**RE: Leadville Mill, File No. M-1990-057  
112d-1 Conversion (CN-3)  
Application Adequacy Review Response**

Please see responses to your Adequacy Review letter dated August 8, 2024.

Located in part of Section, 27, 28, 33 and 34, Township 9 South, Range 80 West, of the 6th Principal Meridian  
Lake County, Colorado

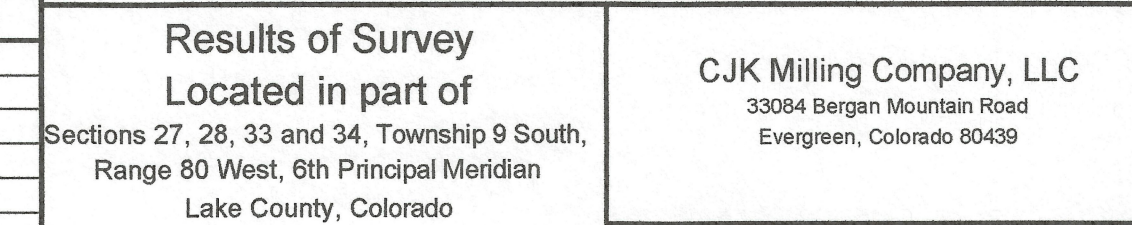
3. Due to the Discrepancy in Acreages in the application form and throughout the Application Exhibits, Please provide a metes and bounds legal description of the Permit Boundary as well as the Affected Area Boundary with the acreages reported pursuant to Rule 6.4.1(1). The metes and bounds survey description with acreage of the Permitted Area shall be performed by a licensed land surveyor.

The Leadville Mill Property, subject of this Adequacy Response (AR) review as well as the neighboring Arkansas Valley Slag (AVS) project (M2021-58) were surveyed by Southwest Land Surveying LLC, 1205 H Lane, Delta, CO 81416 in 2020. This survey was updated in 2023 to adjust the mine permit boundary. Lake County permitted the construction of a residence proximate to the West side of the existing permitted Leadville Mill (M1990-057) property. Although permissible by Lake County Conditional Use Rules for development set-backs for properties zoned Industrial Mining (IM), CJK was informed that the proximity of a residence to our property would make CUP approval virtually impossible. This effectively sterilized this portion of the property, which was slated for future development.

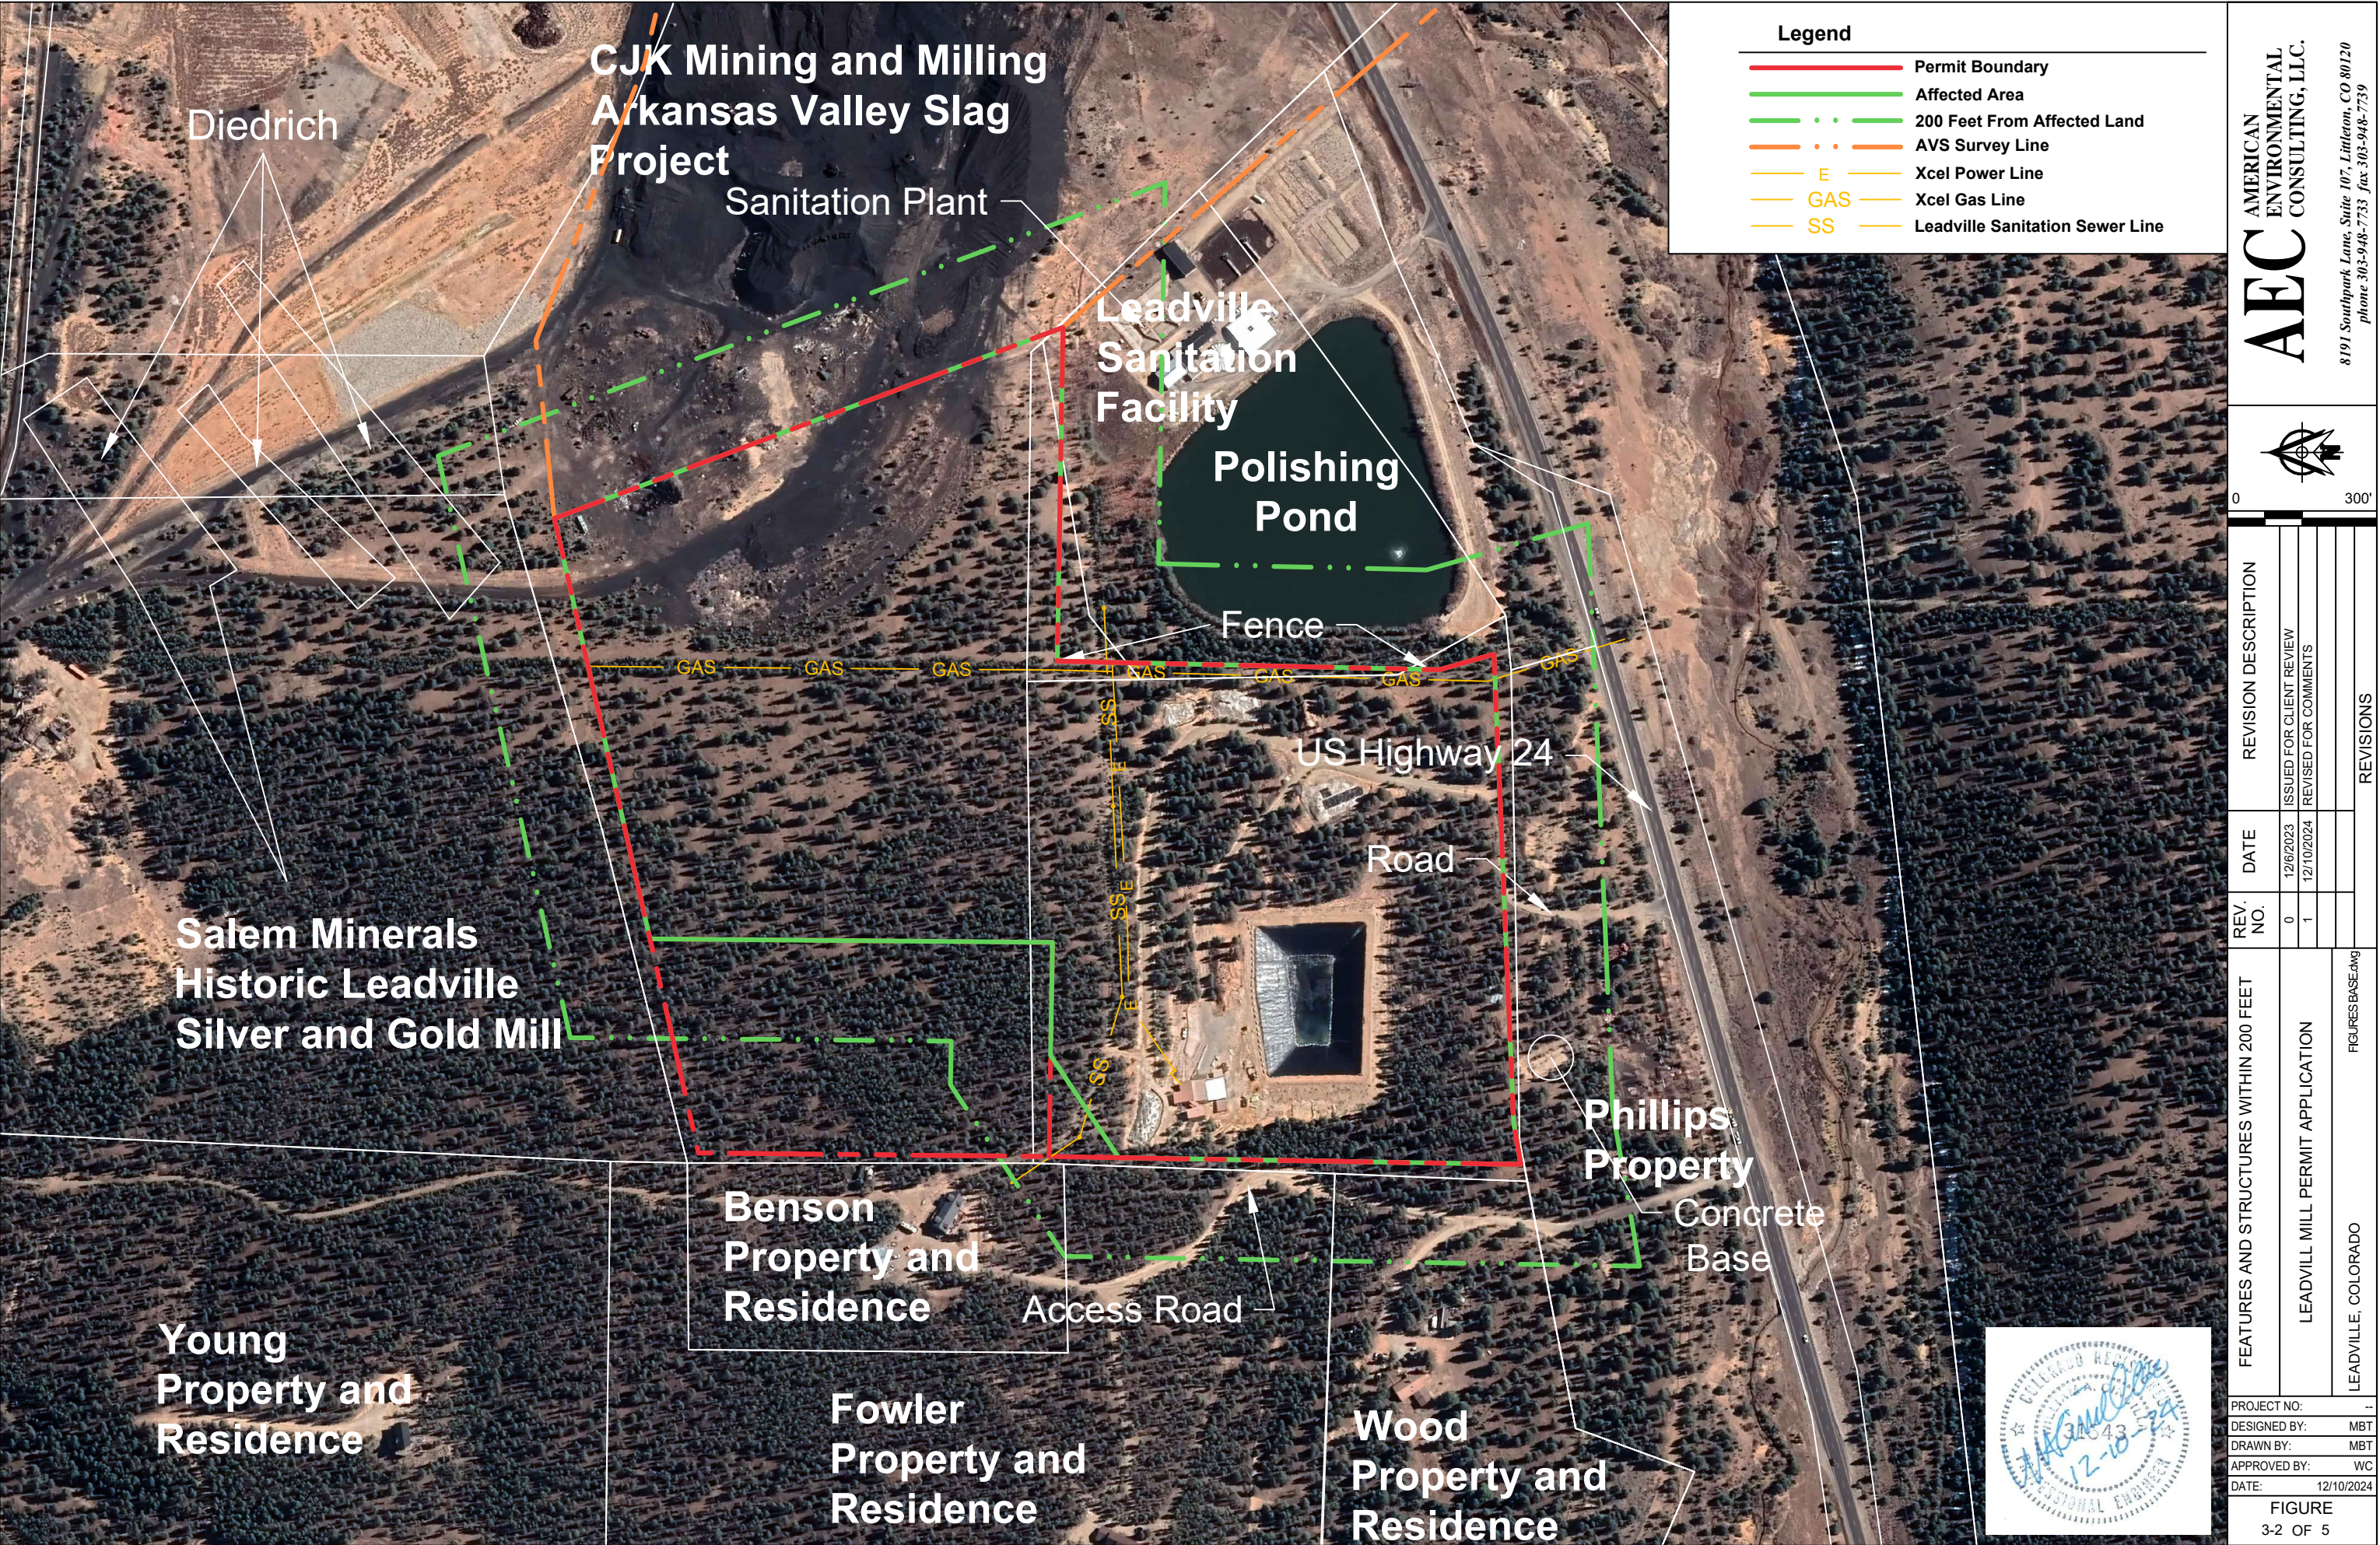
7. The 200 ft buffer appears to extend into Hwy 24 on Figure 3-2. Please confirm that the highway is within the buffer and if so please label the highway on Figure 3-2 per Rule 6.4.3(b). Additionally, please see comments in the Exhibit S section of this review for further information regarding the executed Structure Agreements.

8. Per Rule 6.4.3(g) please show the owner's name on man-made structures within 200' of the permit boundary.

US Highway 24 is within 200-ft. The figure indicates that it is within 200-ft, however the label was truncated. This has been corrected. See updated figure on following page. The Structure Agreement question is addressed in Question 62. This label has been added to the updated Figure 3-2 (rev 1 12.10.2024).

Owner's names have been added. See updated figure on the following page. Owner names have been added to updated Figure 3-2 (rev 1 12.10.2024).

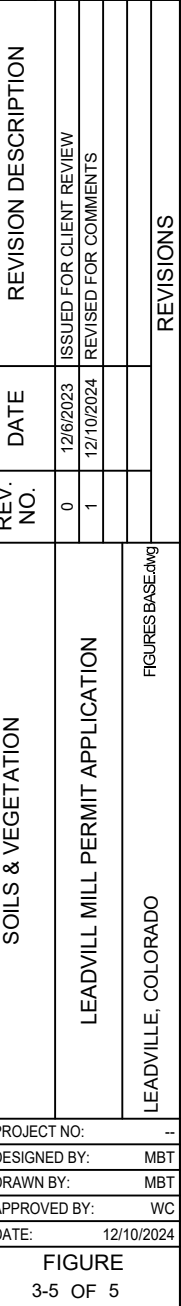
10. Figures 3-4 and 3-5 contain map elements that are not fully identified or described in the Legend. Please submit revised maps ensuring that all items depicted in the map are represented in the Legend.

Figure 3-5 has been corrected and is shown on the following page. Figure 3-4 must also be modified to depict the plant configuration for TNS in place of sodium cyanide as the leachate, and will be included as a Technical Revision.

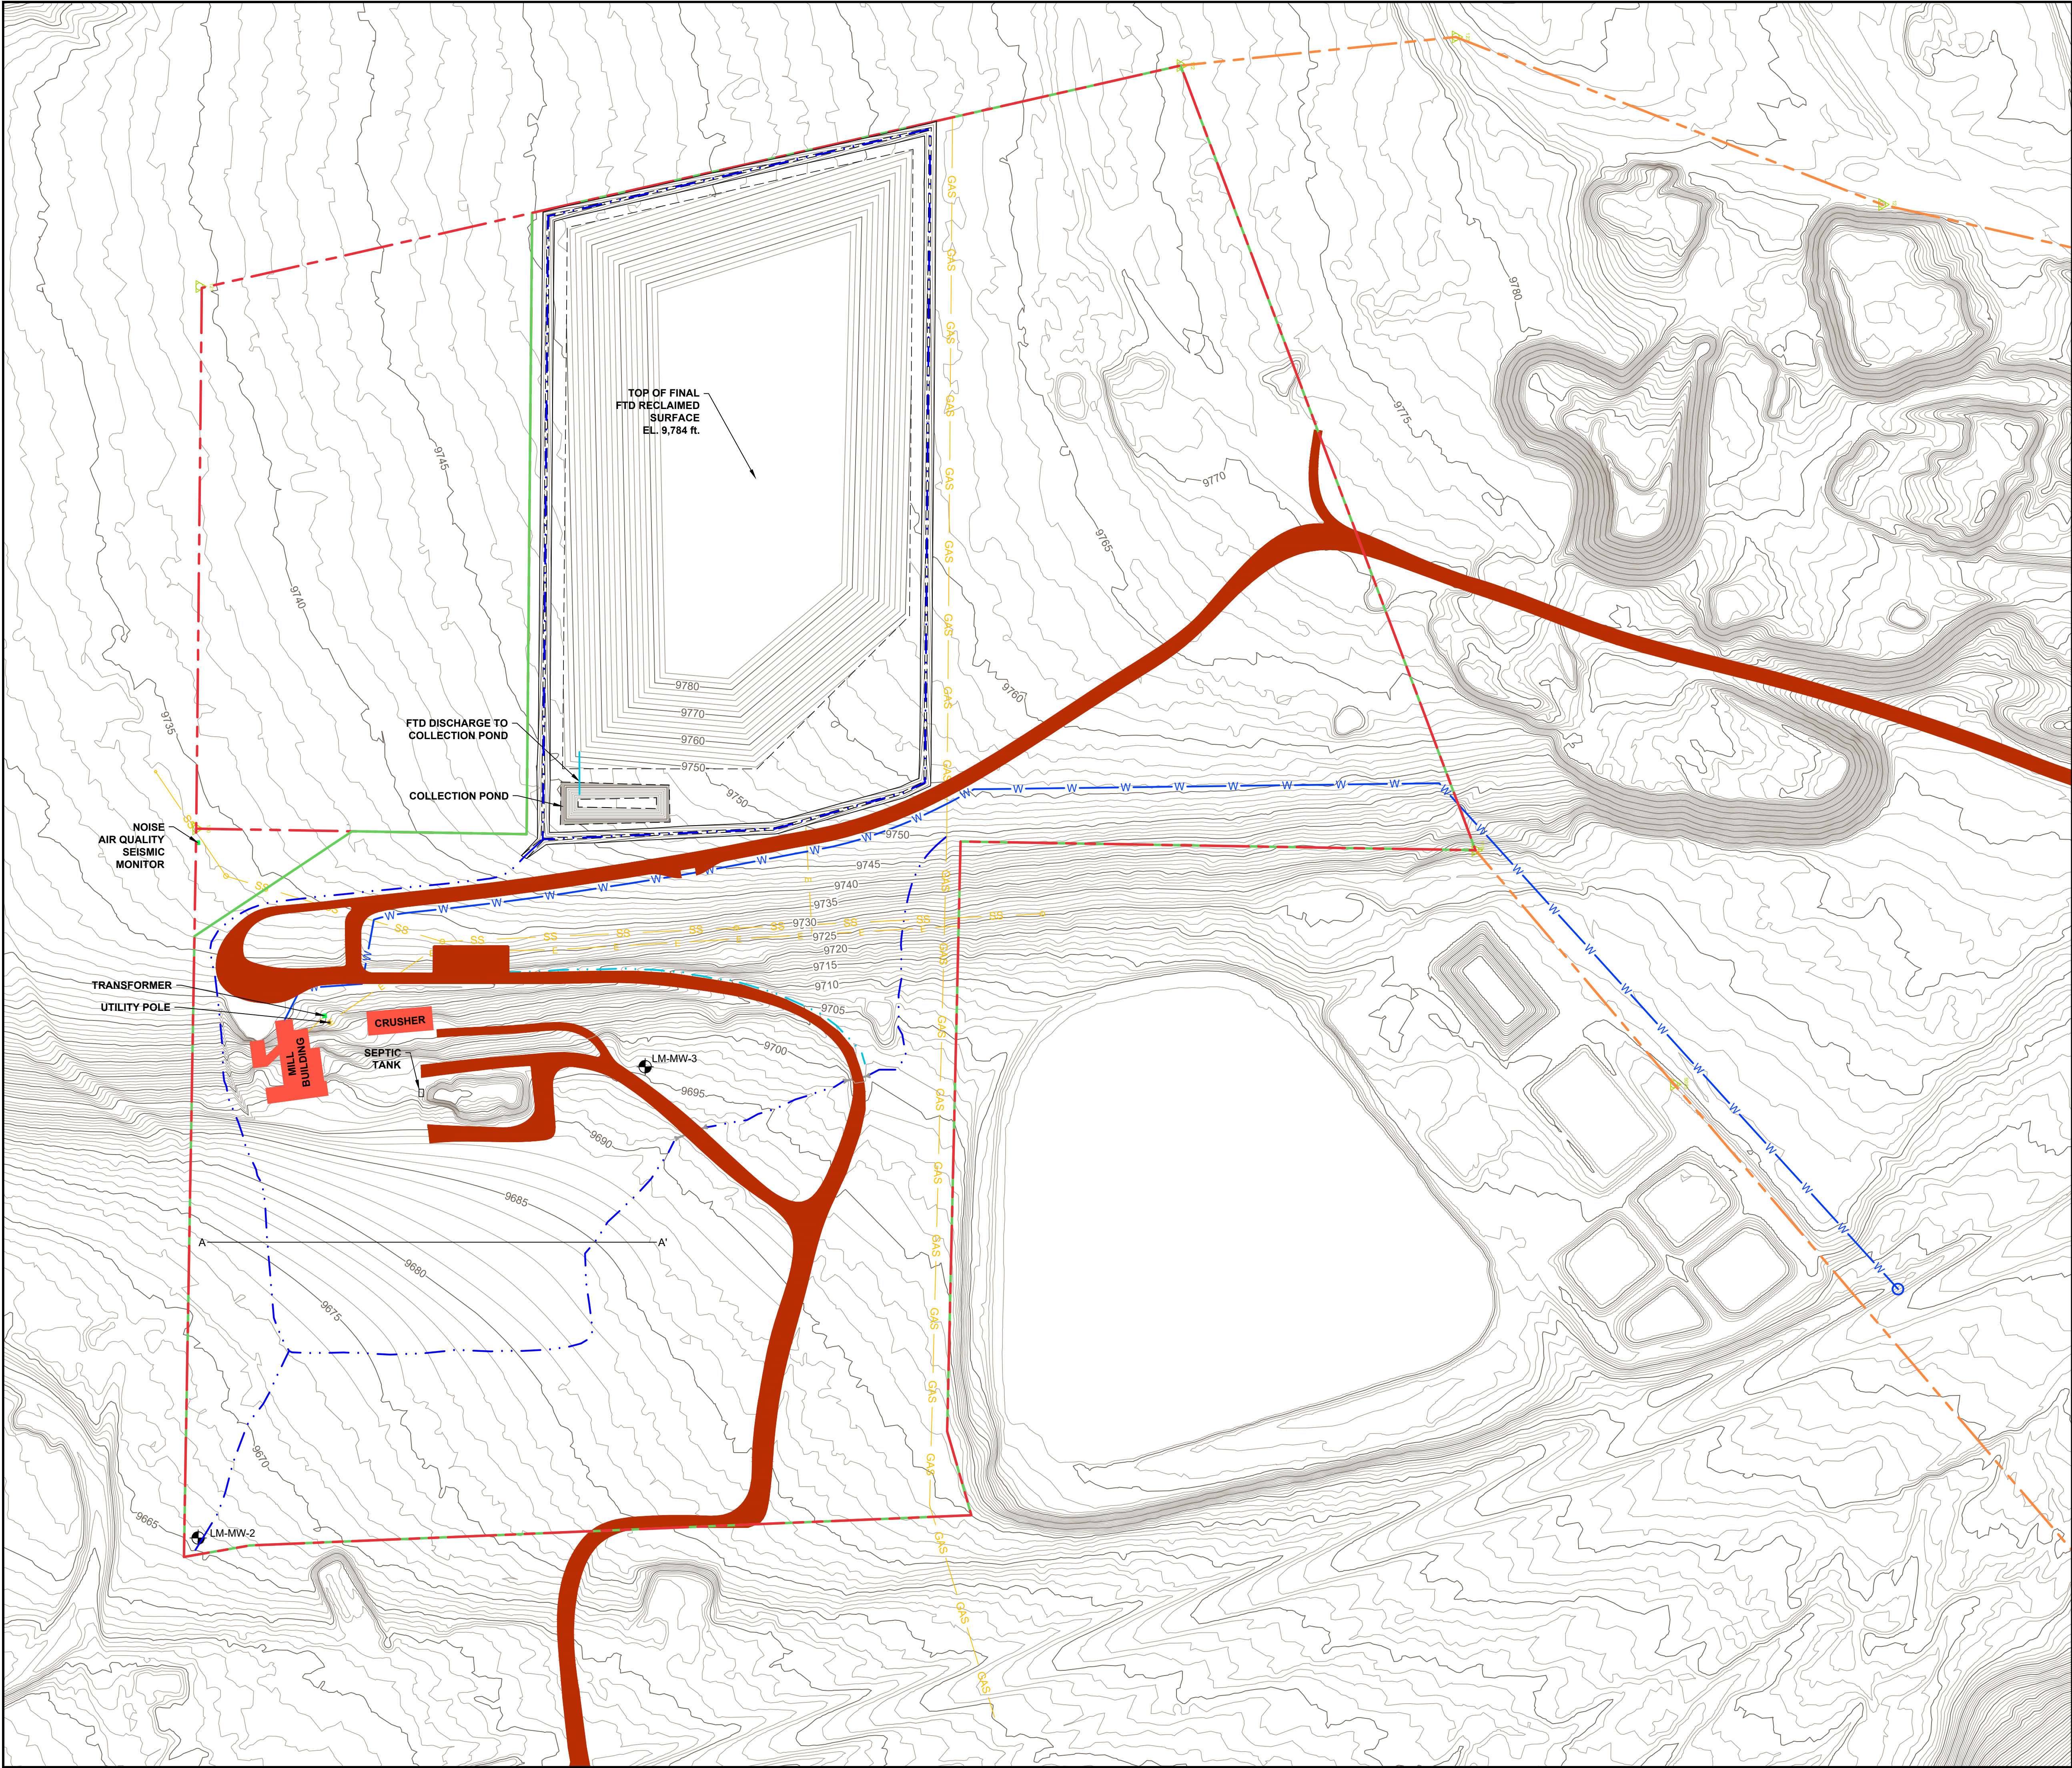
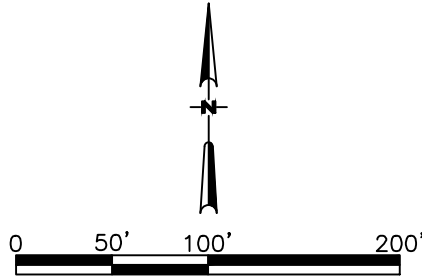
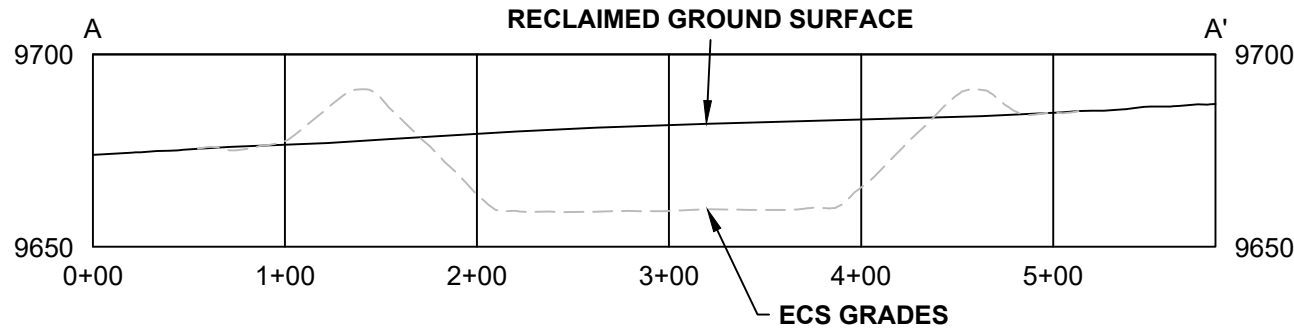
53. The Reclamation Plan Map Figure 6-1 is not signed, please provide a signed version of Figure 6-1. Also, the topographic contours are not labeled. In the revised map, please ensure the contours are labeled.

This Figure has been updated and signed as well as the inclusion of labeled topographic contours. As shown on the next page.
